# **Rezoning Transportation Analysis**

Petition Number: 2018-047

og:	Date	Description	
	04-23-2018	First Review

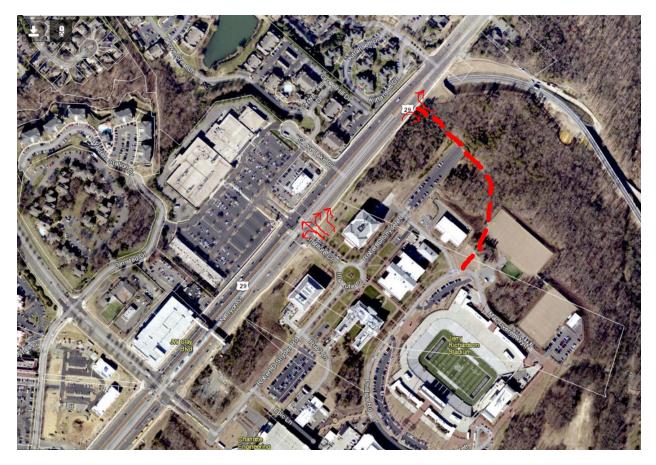
- 5. The petitioner should revise the site plan and conditional note(s) to add a third lane travel lane to the Institute Circle westbound approach (i.e. a single left/thru lane and dual right turn lanes). The dual rights should be channelized, and the pork-chop island should be large enough to serve as a pedestrian refuge with pedestrian signals and pushbuttons to accommodate the pedestrian traffic (see conceptual transportation improvements below).
